To: **Planning Commission**  
From: **Melissa Sonnek, City Planner**  
Date: **July 21, 2020**

**CUP, Site Plan, Rezoning, and Plat for 1201 Robert St #50 and 100 Signal Hills Ave**

**Site Access – Butler Avenue**

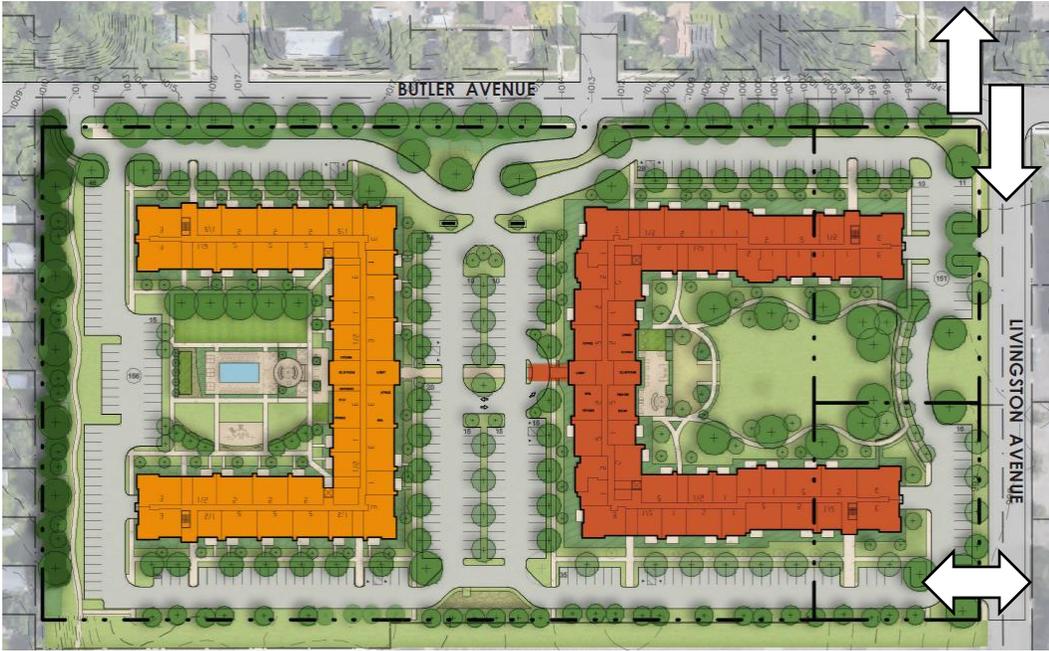
The existing site west access behind the K-Mart building was requested by Dakota County to be closed, to decrease the number of curb cuts and the amount of potential intersection conflict. The primary access to the site from Butler Avenue will be just south of where Gorman Avenue intersects with Butler.
